BETSY PKWY
Mixed Use Planned Development
RESPONSE LETTER #5

Please accept the responses below to your letter dated December 13, 2025 regarding the comments for Betsy Parkway MPD (DCI2025-00003).

ACCESS POINT EXHIBIT

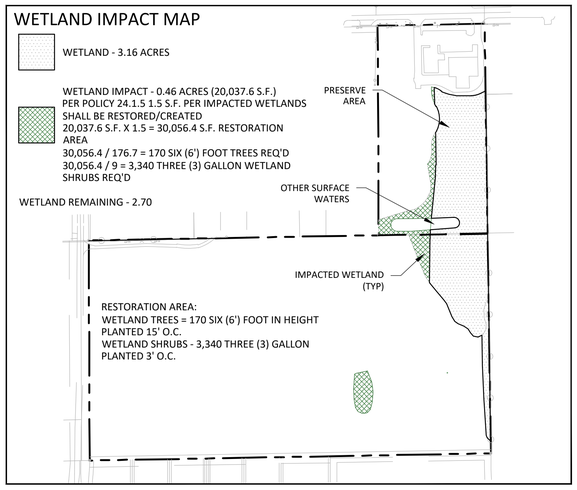
2. Demonstrate the motor vehicle connections on Pine Island Rd. and Betsy Pkwy shown on the plans are in compliance with LDC Section 10-285 (Connection Separation). The connection separation distances, measured edge to edge, must be determined on both sides of the roadway for undivided roadways. Existing and approved access points must be depicted on both sides of the road along the project frontage and to the nearest access point beyond the project frontage in each direction. (Please include all measurements that do not meet that 440' separation, including but not limited to the measurement furthest east. .)

RESPONSE: Please see access point exhibit depicting the closest connections to the subject access points on both sides of the roadway. The necessary dimensions have been provided on the exhibit for Pine Island Roadway as well as Betsy Parkway. The majority of roadways along Betsy are non-maintained. Please also see the revised Schedule of Deviations.

MASTER CONCEPT PLAN
SHEET TITLE

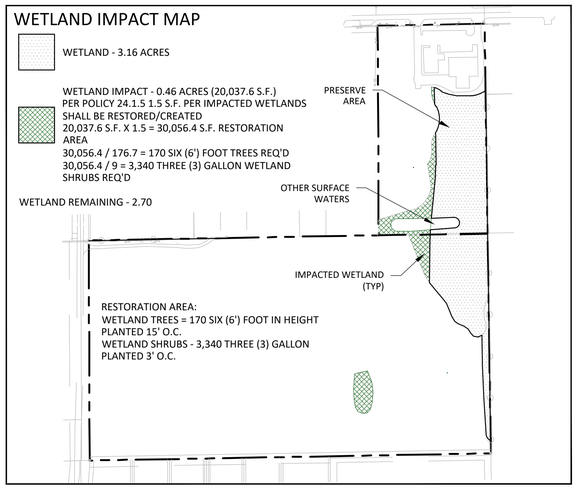
1. Currently the site has one ingress and one egress access, the MCP shows both access points as ingress and egress. (The updated MCP has a note stating ingress only and shows a egress arrow, please revise the MCP accordingly to demonstrate the correct flow of traffic.)

RESPONSE: Please see the attached revised MCP and Access Point Exhibit.
